Dogger Bank South Offshore  
Wind Farms

Project Change Request 2 – Onshore Substation  
Zone

Document Reference: 10.53

Revision Number: 01

**Drawing Name:**  
Figure 4 (b) – Land Plan (Sheet 19/20) – Proposed change

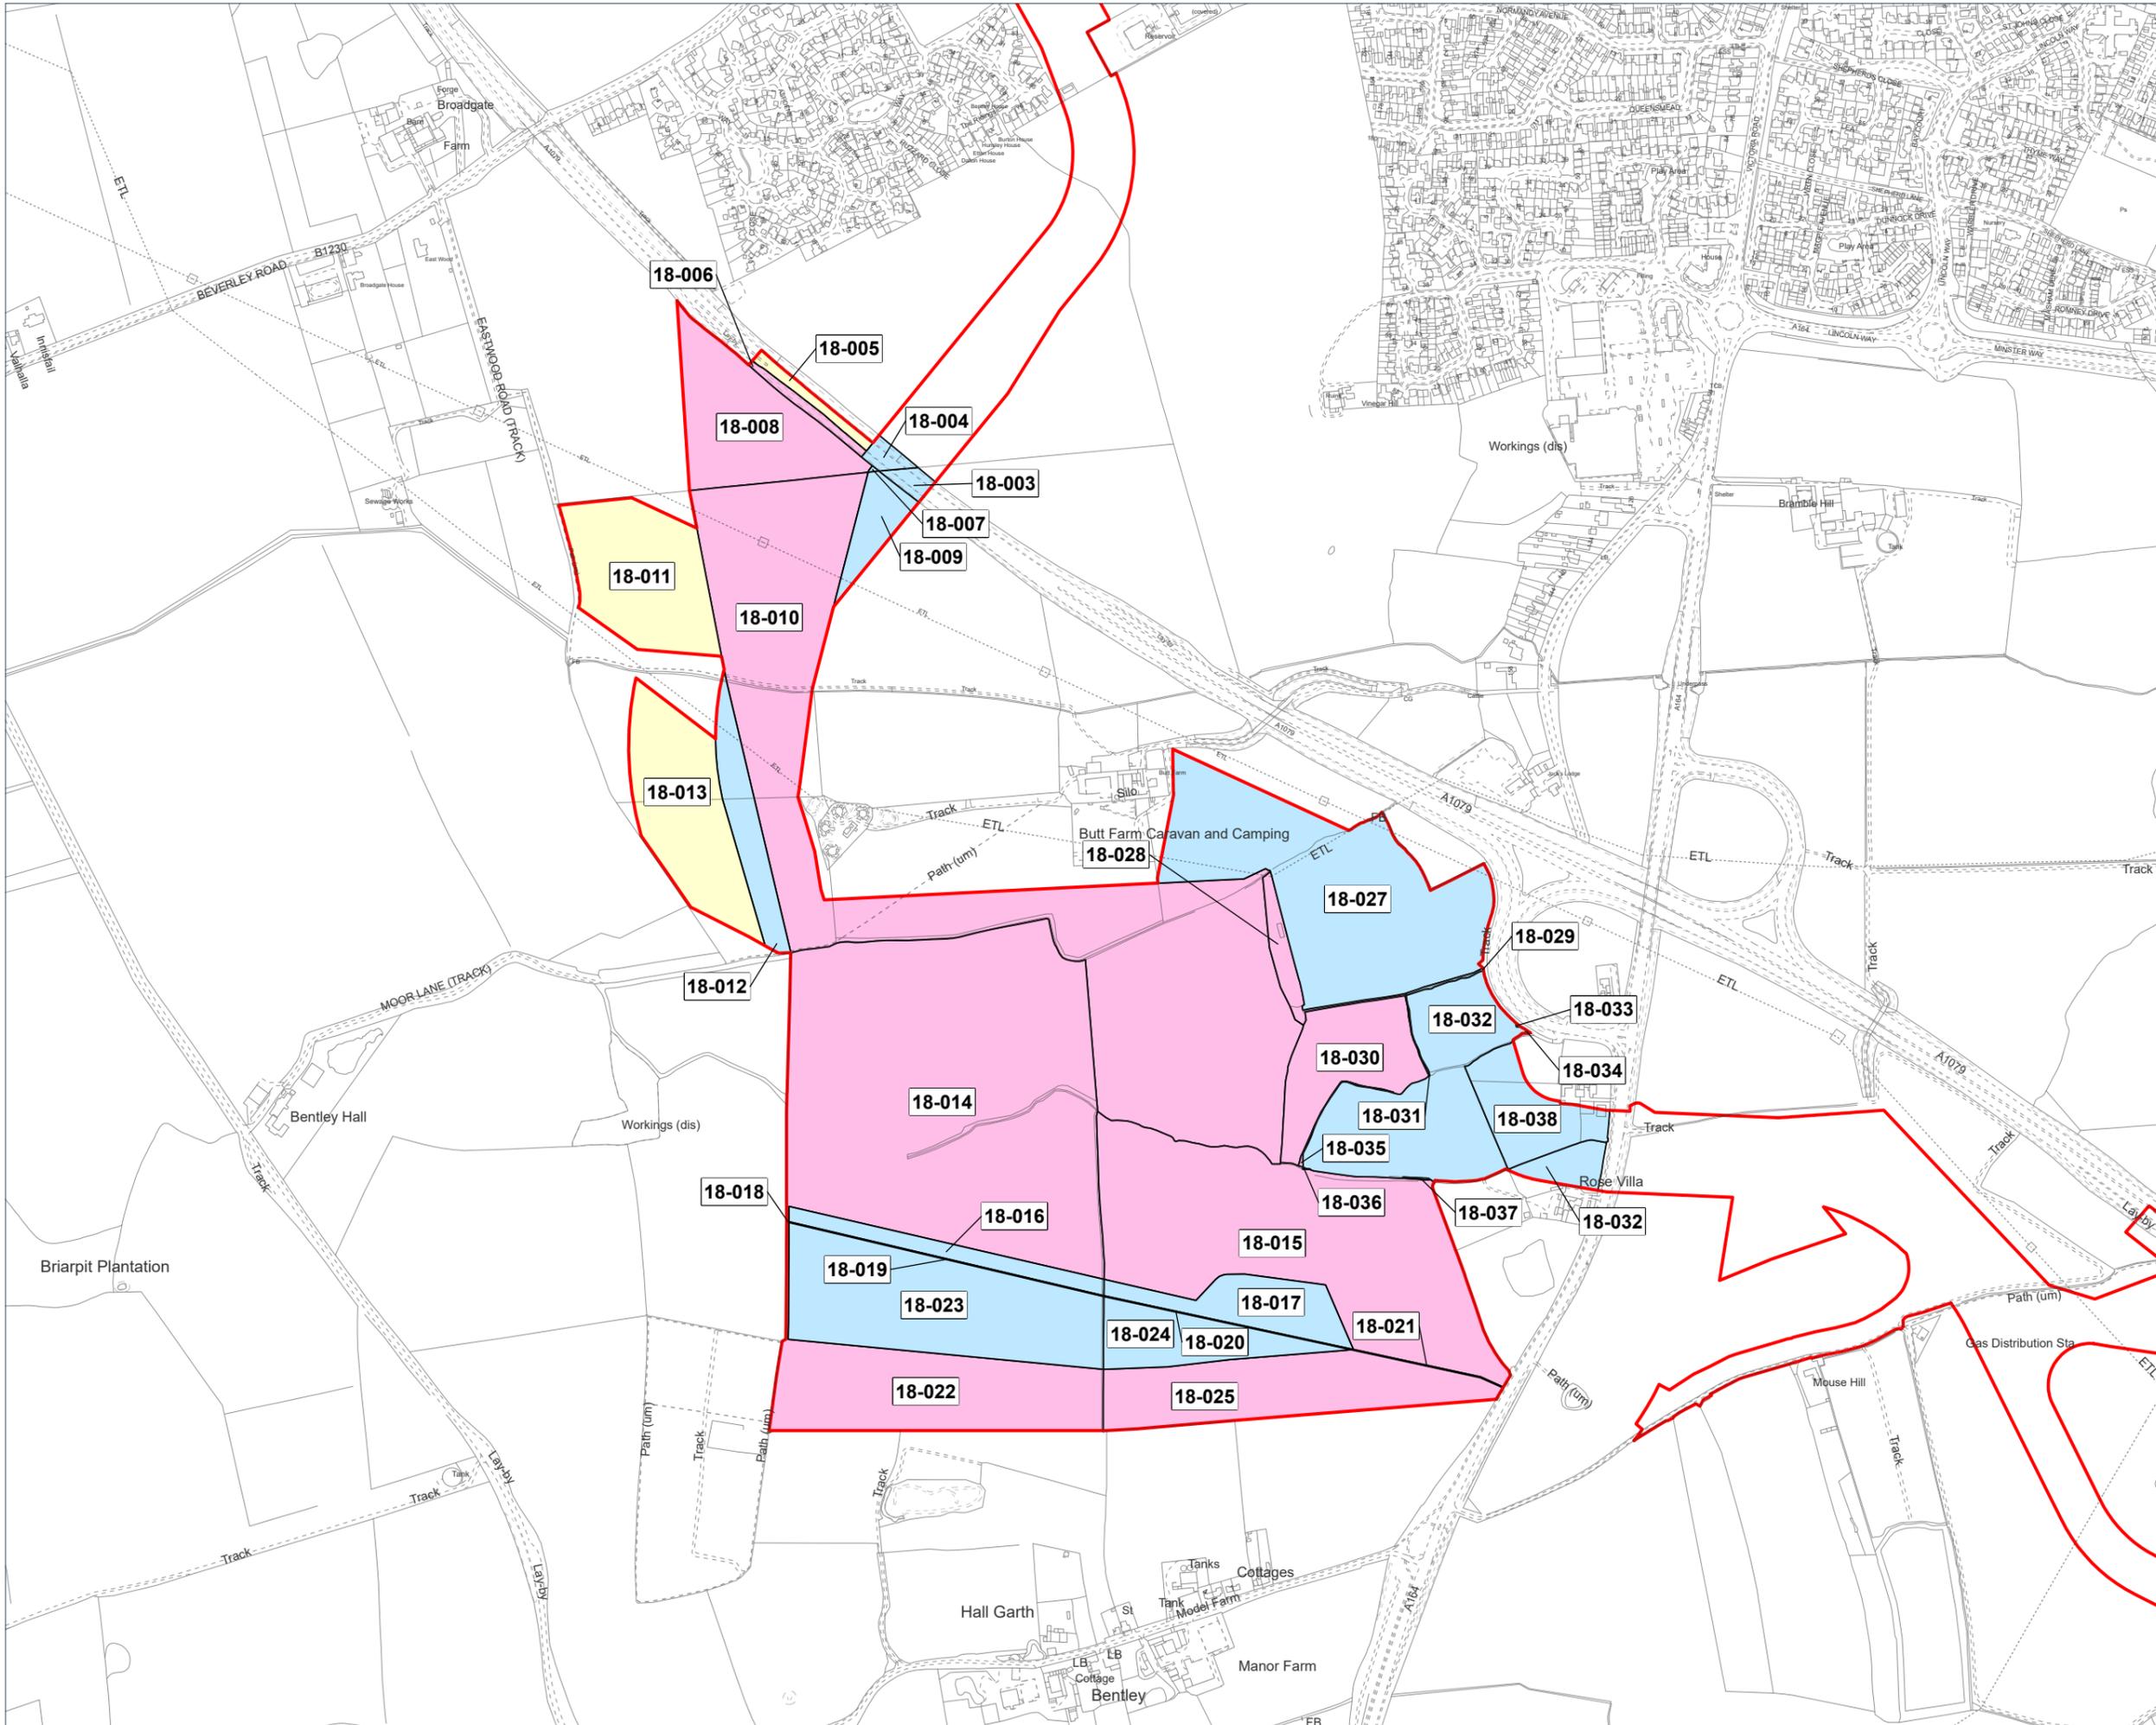
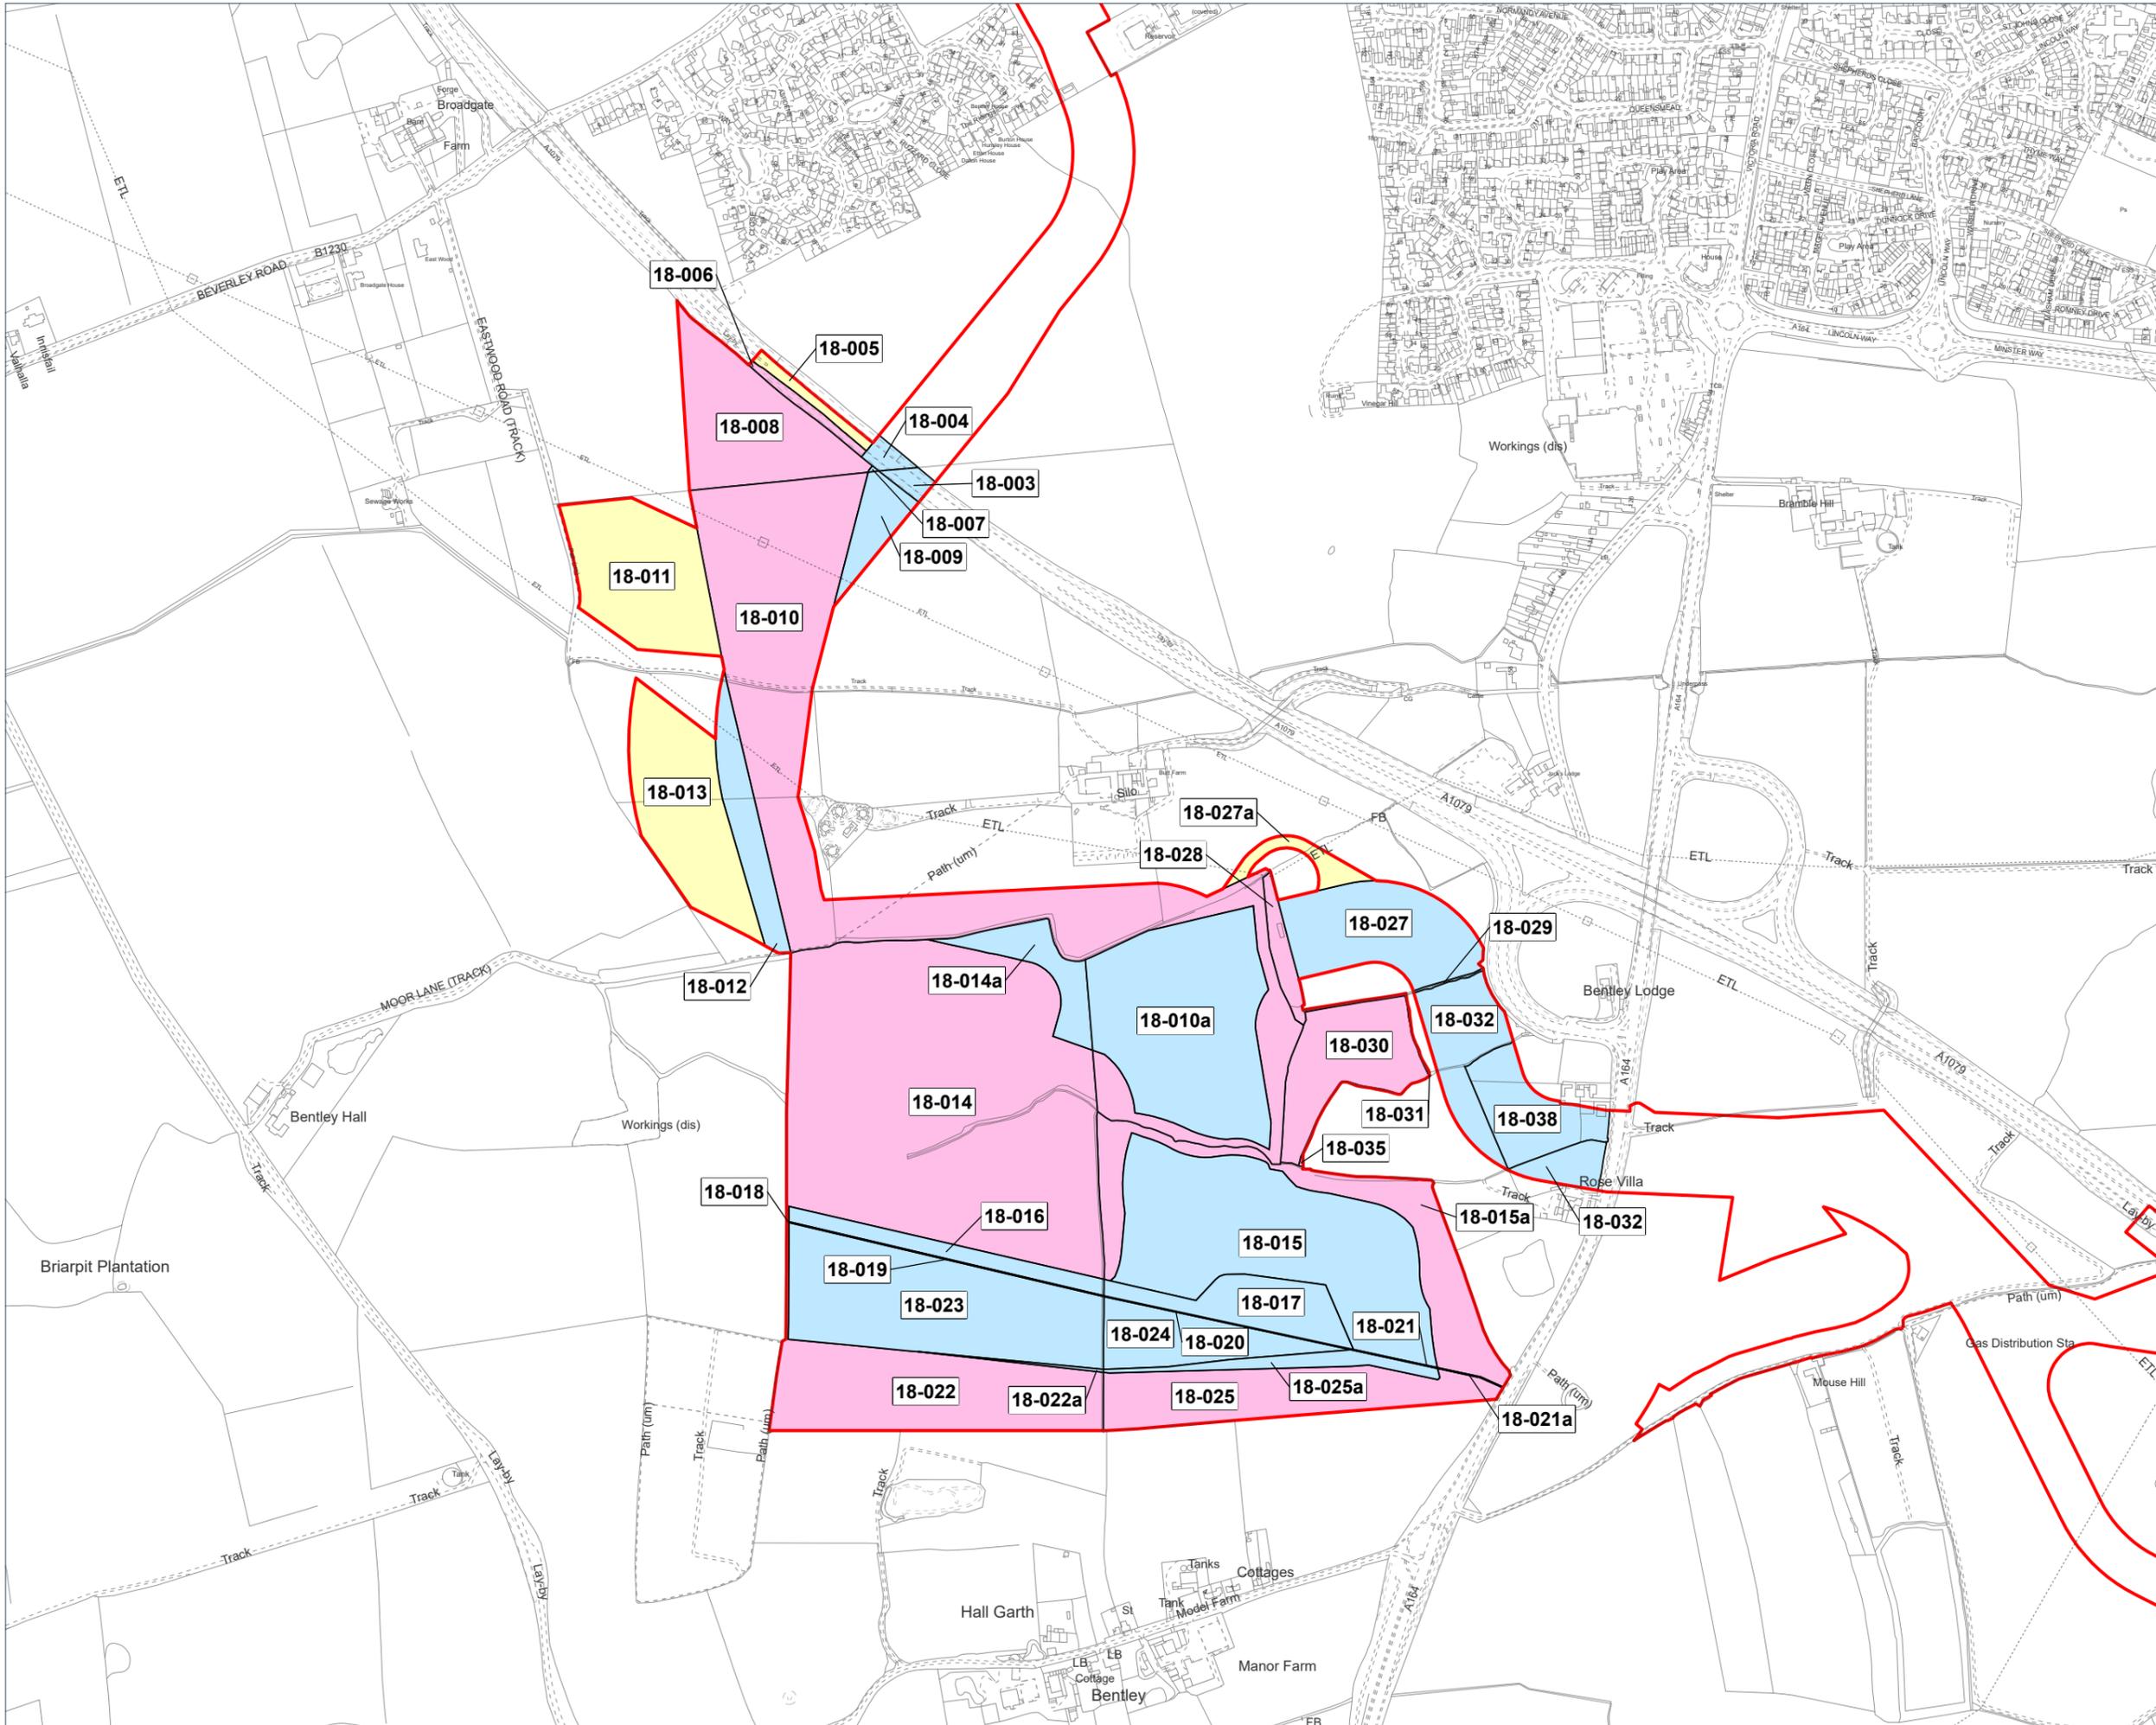
- Figure 4 (a) – Land Plan (sheet 19/20)– Submitted with the DCO Application;
  - Figure 4 (b) – Land Plan (Sheet 19/20) – Proposed Change;
